UNITED STATES
NUCLEAR REGULATORY COMMISSION
OFFICE OF INSPECTION AND ENFORCEMENT
WASHINGTON, D.C. 20555

IE Bulletin No. 80-18

MAINTENANCE OF ADEQUATE MINIMUM FLOW THRU CENTRIFUGAL CHARGING PUMPS FOLLOWING SECONDARY SIDE HIGH ENERGY LINE RUPTURE

**Subject: Centrifugal Charging Pump Operation Following Secondary Side
High Energy Line Rupture**

FIGURE 1
CENTRIFUGAL CHARGING PUMP
TOTAL FLOW DETERMINATION

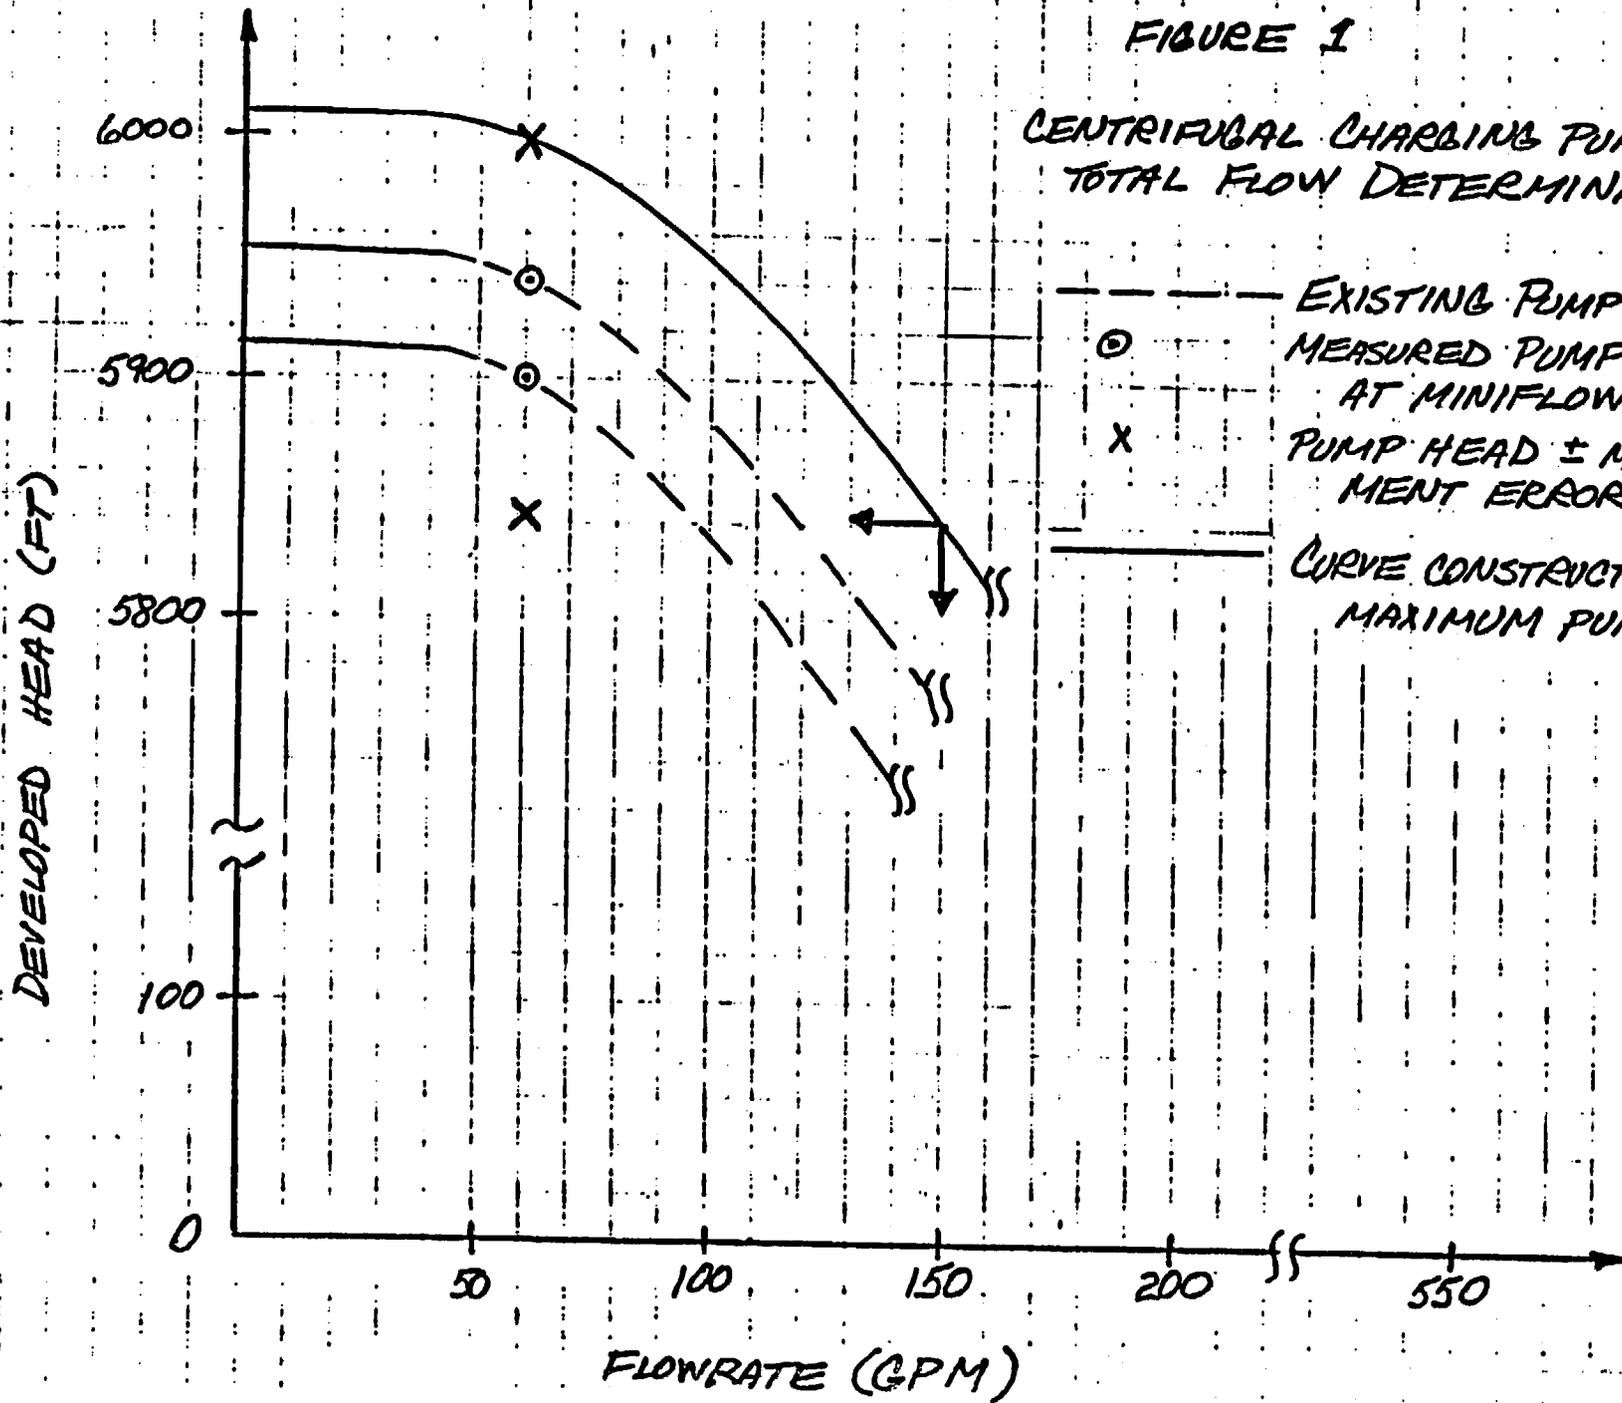
Step 3: Determine total CCP flow. Construct a pump curve for the maximum head pump that is parallel to the actual "as-built" vendor pump curve and passes through the above determined developed head at the miniflow flowrate which is the measured developed head plus the determined measurement accuracy. (See attachment Figure 1.)

Use this head versus flow curve to determine the flow delivered by the maximum head pump (strong pump) at the developed head of the minimum head pump (weak pump) at the miniflow flowrate (i.e., 5842 ft. as determined in Step 1).

Sample: As illustrated in Figure 1, the delivered flow of the strong pump at 5842 ft. is 150 gpm. Therefore, the total flow from both CCPs which guarantees that the weak CCP will be delivering at least 60 gpm is 210 gpm (150 gpm + 60 gpm).
